MEMORANDUM

Subject: Request for Street Determination – 45 Main Street (Renwick S. Tweedy)

INTERDEPARTMENTAL COMMUNICATION

Subject: Review of Renwick Way – 45 Main Street
Determination pursuant to Zoning Bylaw Section 1.3.16(4)

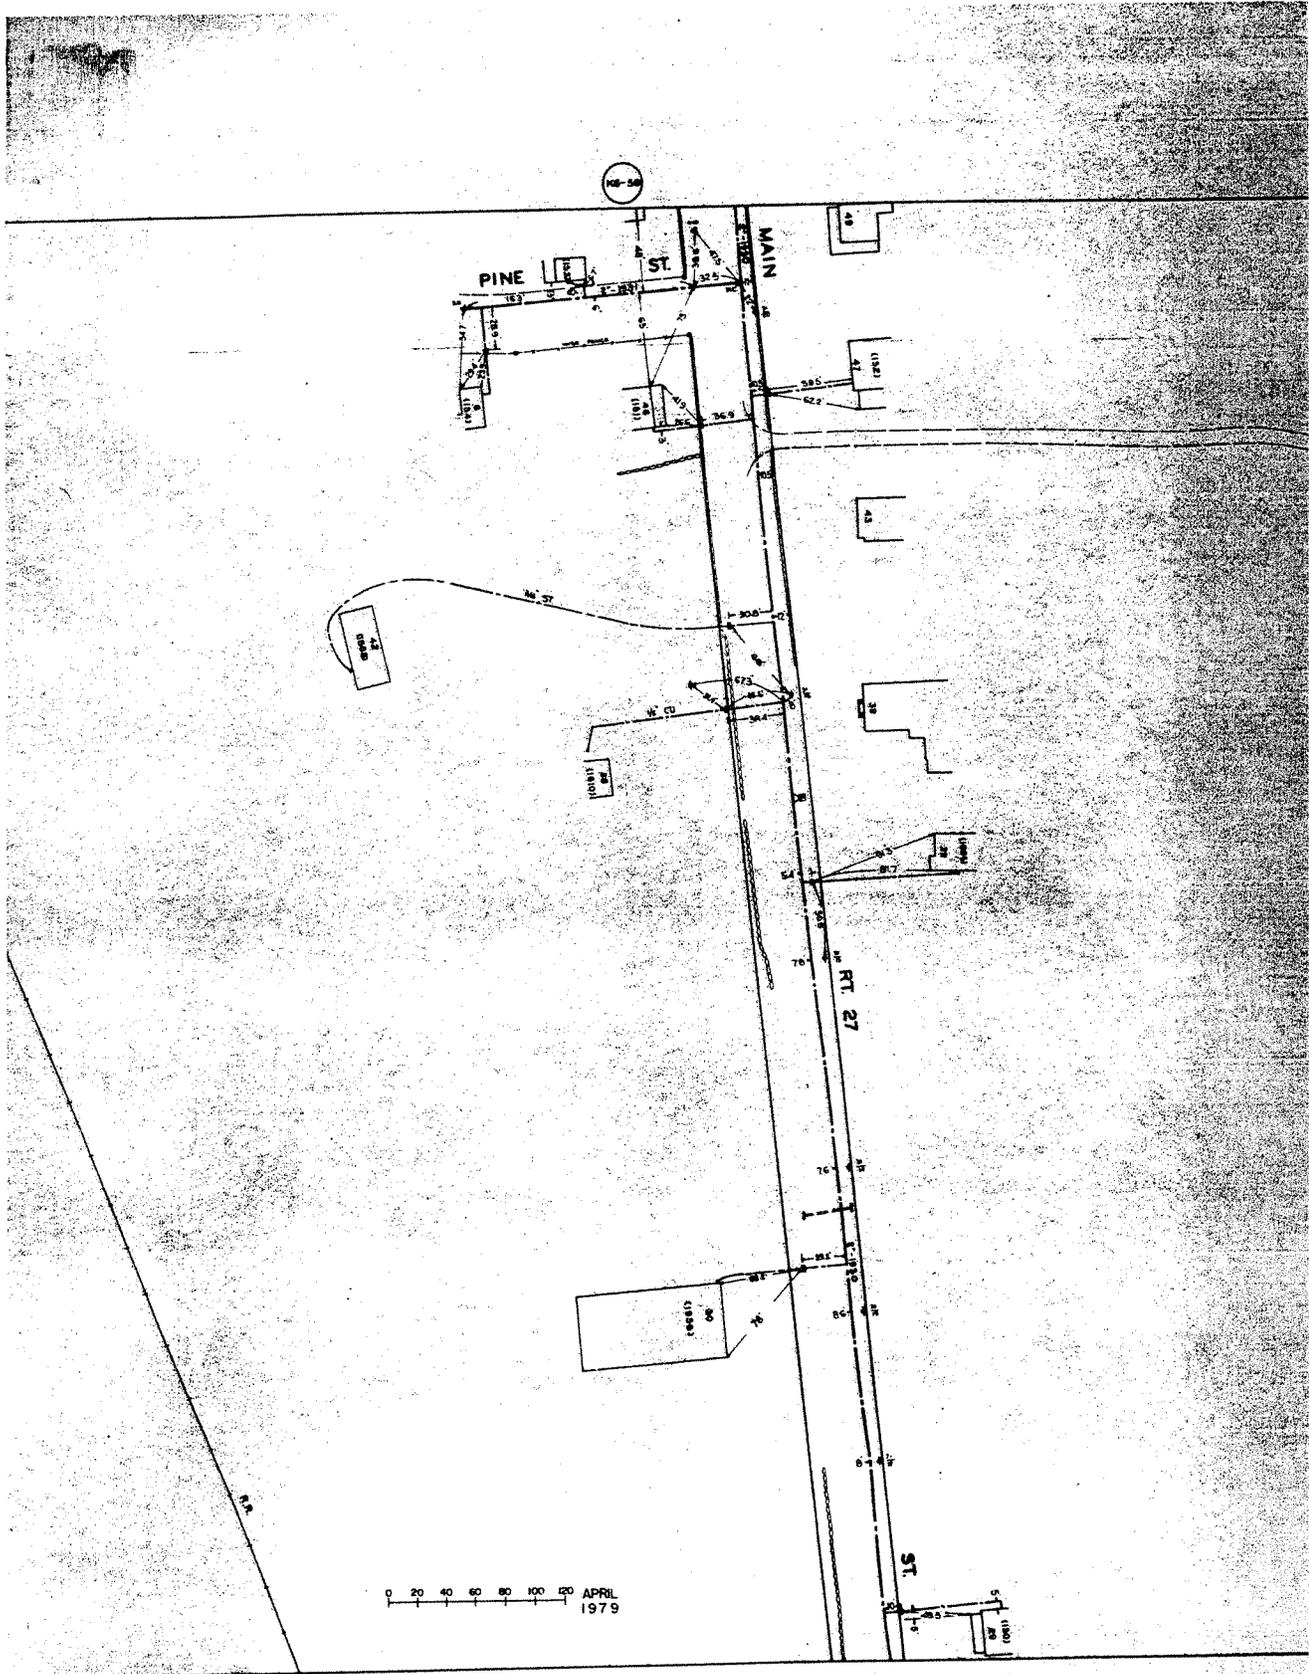
50. The engineer should show the approximate location of the existing gas main in Main Street on the plans.

Has not been addressed – a copy of an old gas map from Keyspan showing the gas main location on Main Street is included with this memo.
